Technical Bulletin

TB 0361 – 2 Way LV Link Panel Replacement for Federal switches in S/L Columns

Date: 13/11/2024

Figure 1: New LV 2-Way Link Panel

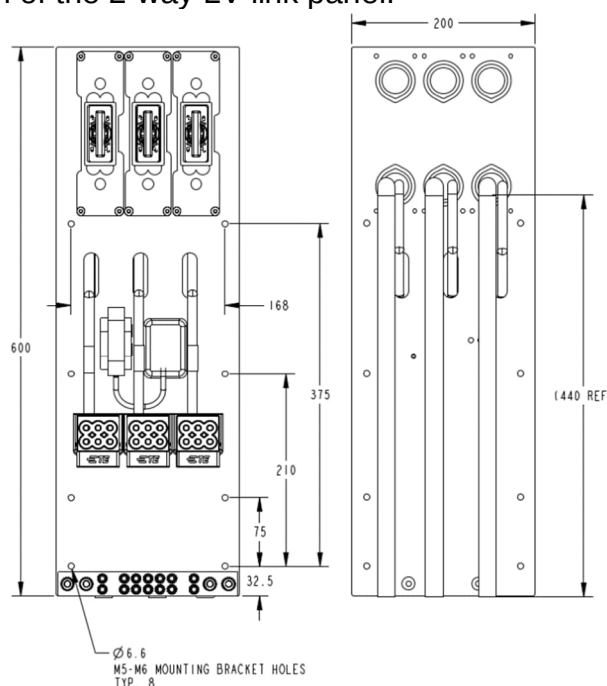
To inform stakeholders of the introduction of a LV 2-way link panel to replace failing 'Federal switches' used in enlarged base street light columns.

Endeavour Energy inherited enlarged base streetlight columns, throughout the Greater Western Sydney Region, from Prospect Electricity. Many of these columns contain 'federal switch' type panels which are now approaching end of life. As no suitable replacement was commercially available in the market, Endeavour Energy engaged with a manufacturer to develop a LV 2-way link panel.

A trial was successfully conducted at column 6552 at Demyrick Ave Lurnea on 16th October 2023 by the Hoxton Park Field Crew using existing installation procedures. In general, feedback from the trial was positive and key learnings observed during the installation have led to further improvements to the design of the 2-way LV link panel.

10 units of the 2-way LV link panels, TE part number TAP10419, have been delivered and spread across Kings Park, Windsor, Penrith, Hoxton Park and Parramatta Depots as part of the pilot program. This will allow field crews to provide feedback and for further improvement if required.

Item Description	Supplier Part Number	Material Number
PANEL SL,PWR DIST,URD COLUMN,2WAY LINK	TAP10419	1000010600
